PLAN COMMISSION MEETING AGENDA

STAFF REPORT

Agenda Item # 5a: Request to Amend the Site Plan for Lakeview Dental Clinic

Applicant: Brad Allen on behalf of Lakeview Dental Clinic

Exhibit A - Landscape Plan

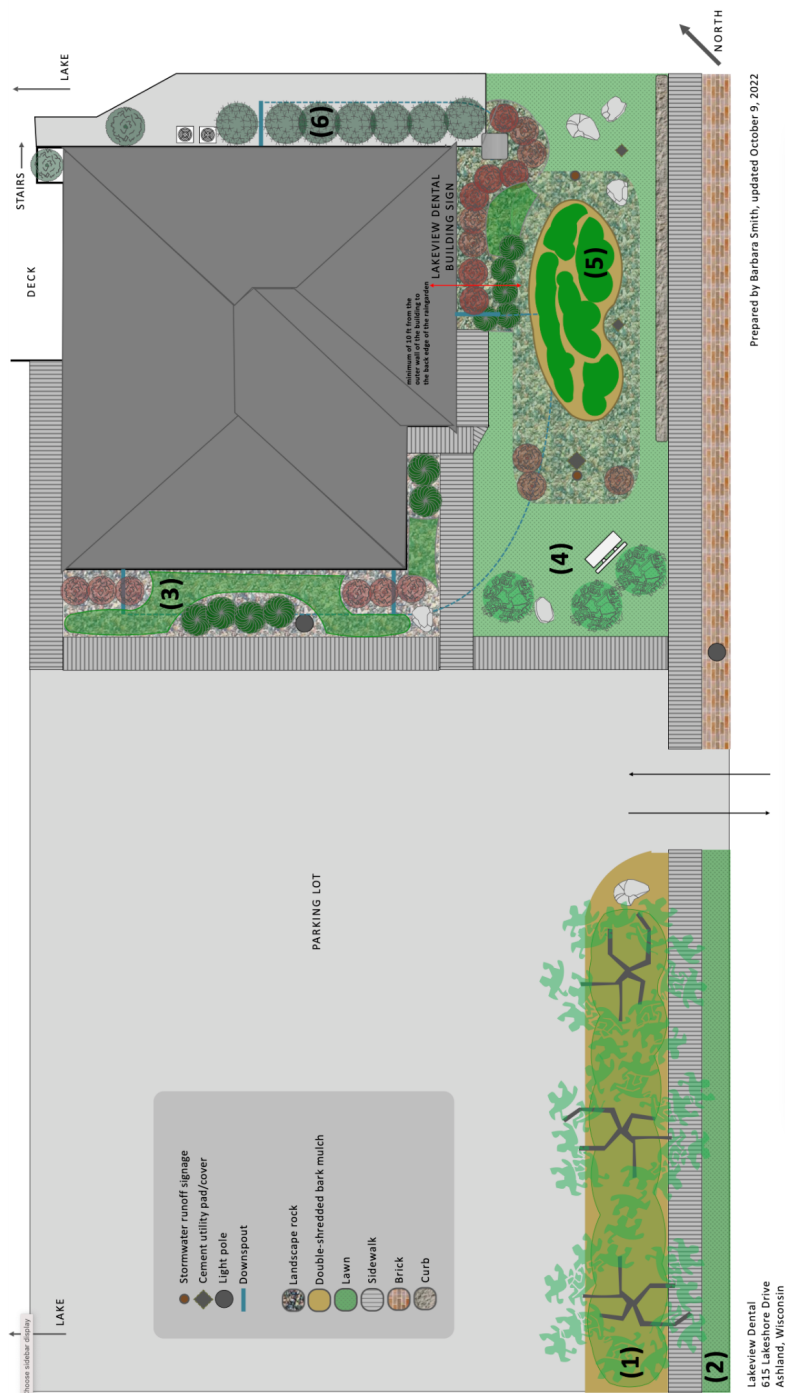
A condition of approval in the original Site Plan review was the applicant must submit a full landscaping plan with a species list. The applicant has submitted their landscaping plan for review with six distinct sections that are indicated within the plans. The provided plans are consistent with standards outlined in the Unified Development Ordinance and will enhance the visual nature of the property. The proposed landscaping plans are extensive, detailed, show that a variety of species will be on the property with 11 species being native to Wisconsin, and indicate that a raingarden with informational signage will be installed.

Staff has reviewed these plans and recommends APPROVAL with the following conditions:

- Section (2) which is the space between the road and the sidewalk be brick pavers as recommended by Public Works
- No plantings will interfere with the required vision triangle and will be maintained
- No plantings (other than seed or sod associated with maintained lawns) shall be placed in the public right-of-way without the written approval of the Public Works Director or Designated Authorized Agent (UDO Section 6.4 A.,6.,e.,3)
- Plant material centers shall be located at least three (3) feet from fences and parcel lines. (UDO Section 6.4 A.,6.,e.,4.)
